Rezoning Transportation Analysis

Petition Number: 2019-029 General Location Identifier: 12703509

Date	Description	
03-21-2019	First Review

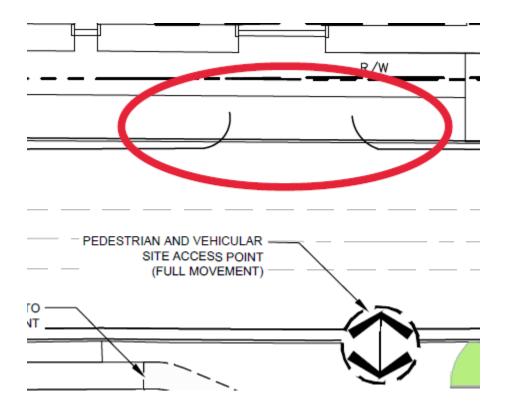
- a. Upon completion and review of the Traffic Impact Study, the proposed access drive(s) will be evaluated and may result in being eliminated, restricted, or condensed to reduce conflict points, as approved by CDOT and NCDOT.
- 3. The petitioner should revise the site plan to include all existing driveways along East 7th Street and North Caswell Road in the existing right-of-way. CDOT cannot verify the location of the driveway shown in the picture below.
